Disability Access Report

St Michaels Nelson Bay
12 Sproule Street
NELSON BAY NSW

For: Catholic Schools Office
Diocese of Maitland-Newcastle
Ref: LP_20094

Figure 3 | Block B

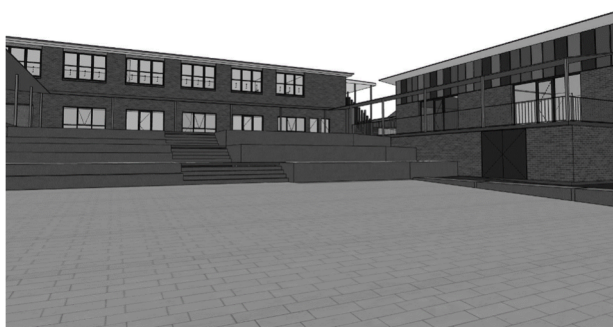
- a. Provide ambulant toilets within the building for male and female use per BCA.
